BUILDINGS 5 & 6 RENOVATIONS

San Mateo County Community College District

ENLARGED MECHANICAL
DUCTWORK PLAN

Drawing Number **M3.3**

1 ENLARGED MECHANICAL DUCTWORK PLAN - FIRST FLOOR

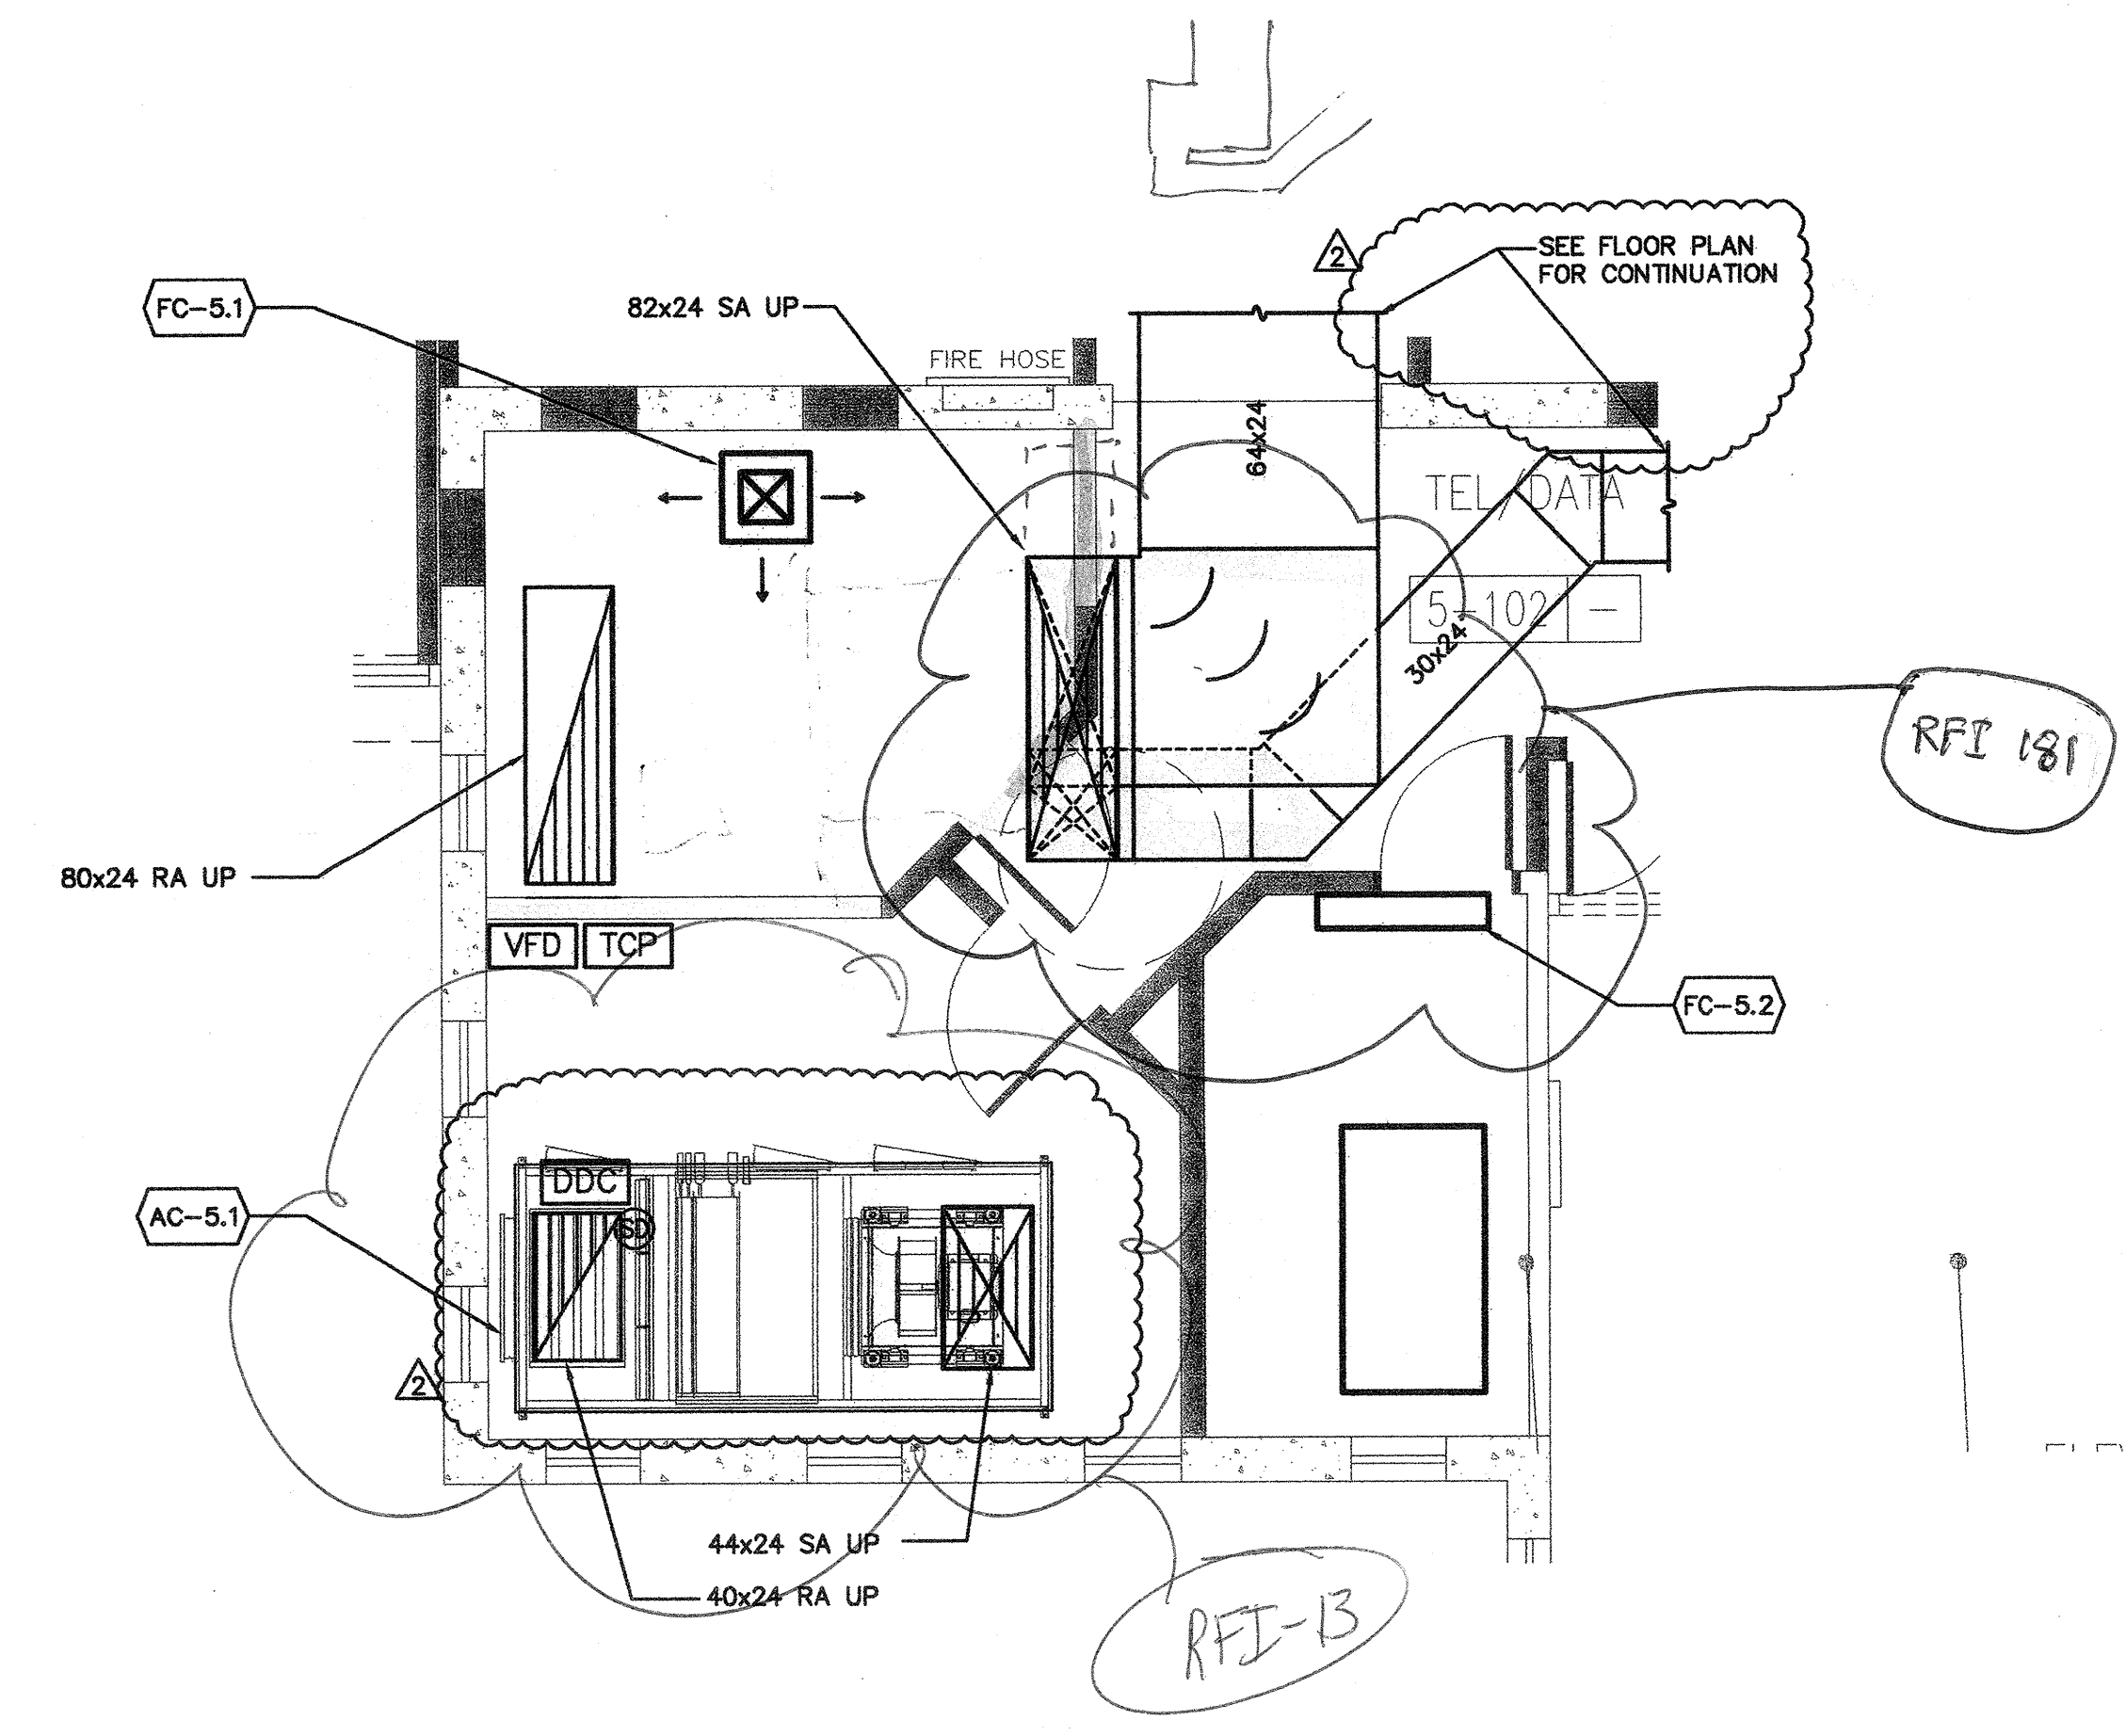
RFI-278
ATTN 6.1 VFD'S
